UNITED STATES PATENT AND TRADEMARK OFFICE

10/561,353

Office Action Summary	Application No. 10/561,353	Applicant(s) SHINOBI, NORIKAZU	
	Examiner ROBERT J. HICKS	Art Unit 3781

DETAILED ACTION

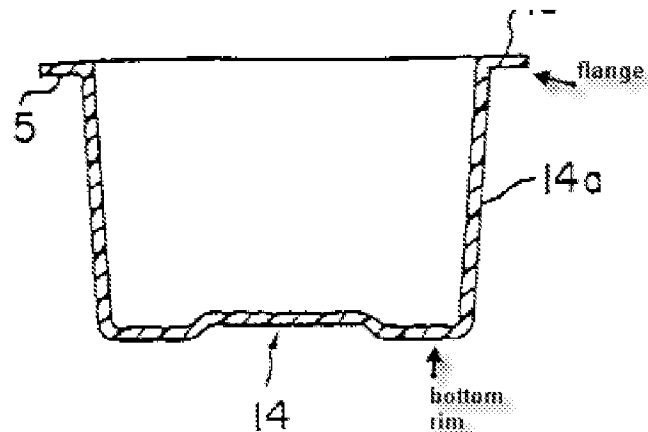
Shinoki does not expressly disclose that the flange has dimensions of 2 mm or more in flange width and 0.5 mm or more in flange thickness, or that the bottom rim has a dimension of not less than 0.3 mm but not more than 20 mm. However, the patent to Okabe – a plastic container made by molding – discloses a container [Okabe, 14] with a flange [Okabe, 15] and a bottom rim portion [Okabe, 14b], in which the flange could have a width ranging between 1.0 and 2.5 mm, and a thickness ranging from 0.2 to 1.0 mm [Okabe, Col. 24 Lines 15-17], and in which the bottom rim portion could appear to have a thickness between 0.3 mm and 2.0 mm [Okabe, Col. 10 Lines 6-9]. It would have been obvious at the time of the invention to one of ordinary skill, with known options available to one of ordinary skill within their technical grasp leading to anticipated success, to modify the dimensions of the flange and bottom rim portion in the Shinoki container to have a flange width more than 2.0 mm plus thickness more

than 0.5 mm, and a bottom rim with a dimension between 0.3 and 2.0 mm, as suggested by Okabe, since it has been held that discovering an optimum value of a result effective variable involves only routine skill in the art. See *In re Boesch*, 617 F.2d 272, 205 USPQ 215 (CCPA 1980).

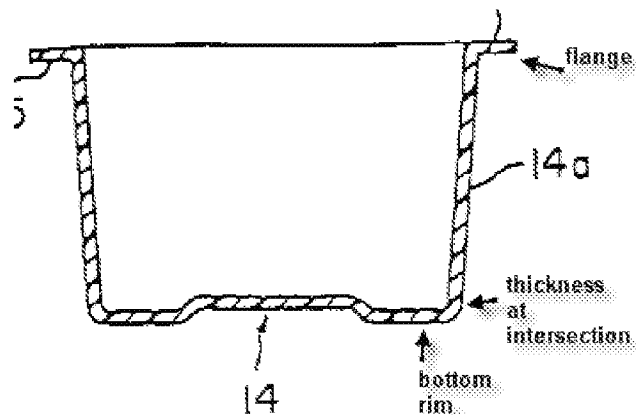
12. Regarding Claim 4, Shinoki in view of Okabe discloses all the limitations substantially as claimed, as applied to claims 2 and 3 above, respectfully; further, Okabe teaches the relationships among the wall thickness of the intersection between said bottom rim and the bottom part of the container (A) [**Okabe**, 14a, 14b], the wall thickness of the bottom part of the container (B) [**Okabe**, 14b] and the wall thickness of the side part (C) [**Okabe**, 14a] of the container are: $A \leq 2 \times B$ and $A \leq 2 \times C$. The wall thicknesses of the bottom rim portion and the side wall appear to be 1.1 mm, and the wall thickness at the intersection of the bottom wall and the side wall appears to also be 1.1 mm. Therefore, the relationship between the wall thicknesses appears to be met in Okabe.

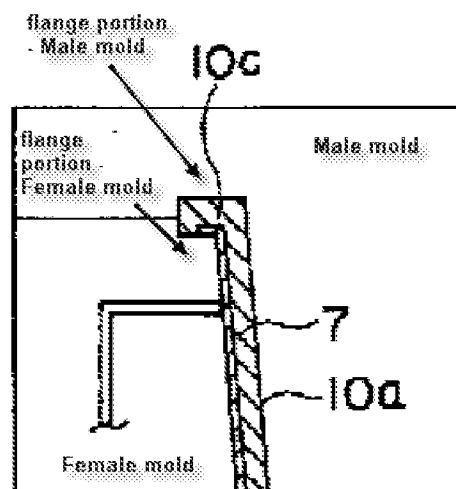
13. Regarding Claim 5, Shinoki in view of Okabe discloses all the limitations substantially as claimed, as applied to claims 1, 2, and 3 above, respectfully; further, Shinoki teaches the container [**Shinoki**, 10] is fabricated by using said female metal mold [**Shinoki**, 3] and male metal mold [**Shinoki**, 4] which are a female metal mold and a male metal mold joined at the flange part in the formed container [**Shinoki**, Fig. 2a], and so designed that the flange width of a flange part formed by the female mold is smaller than the flange width of a flange part formed by the male mold [**Shinoki**, Fig. 2a].

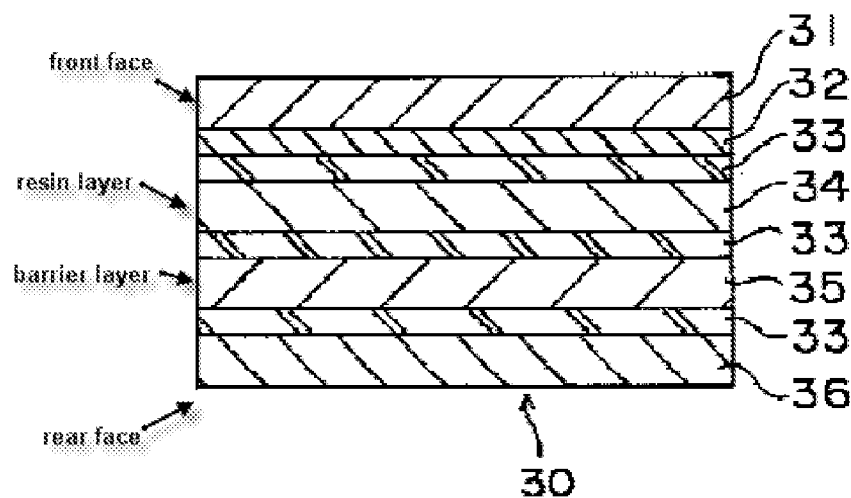
14. Regarding Claim 7, Shinoki in view of Okabe discloses all the limitations substantially as claimed, as applied to claims 1, 2, and 3 above, respectfully; further, Shinoki teaches the label [Shinoki, 1] is a label having a configuration [Shinoki, 30] in which a plurality of thin films are stacked, the thin film positioned on the front face [Shinoki, 31] and the thin film positioned on the rear face [Shinoki, 36] consist of thin films of the same material [Shinoki, Fig. 6], and further at least a resin film layer [Shinoki, 34] and a barrier layer [Shinoki, 35] having a defined strength or barrier layers having a defined strength are stacked between these thin films [Shinoki, Fig. 6]. The cross-sectional area of Figure 6 appears to show that the two outermost layers are made of the same material. See *MPEP* § 608.02 (IX).

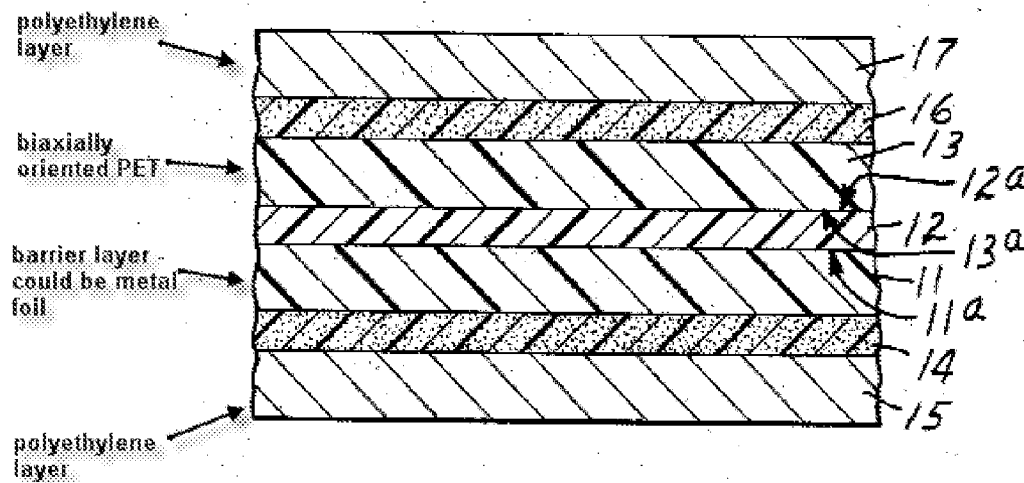
Shinoki in view of Okabe discloses all the limitations substantially as claimed, as applied to claims 1, 2, and 3 above, respectfully. The Shinoki and Okabe combination does not expressly disclose that the thickness of said label is not more than 150 μm ; however, the publication to Tachi – a bottle with an attached label – teaches a resin container [Tachi, 1] with an attached label [Tachi, 2] of thickness less than 150 μm [Tachi, Paragraph 39 Lines 1-3]. It would have been obvious at the time of the invention to one of ordinary skill, with known options available to one of ordinary skill within their technical grasp leading to anticipated success, to modify the thickness of the labels in the Shinoki and Okabe combination container to be less than 150 μm , as suggested by Tachi, since it has been held that discovering an optimum value of a result effective variable involves only routine skill in the art. See *In re Boesch*, 617 F.2d 272, 205 USPQ 215 (CCPA 1980).
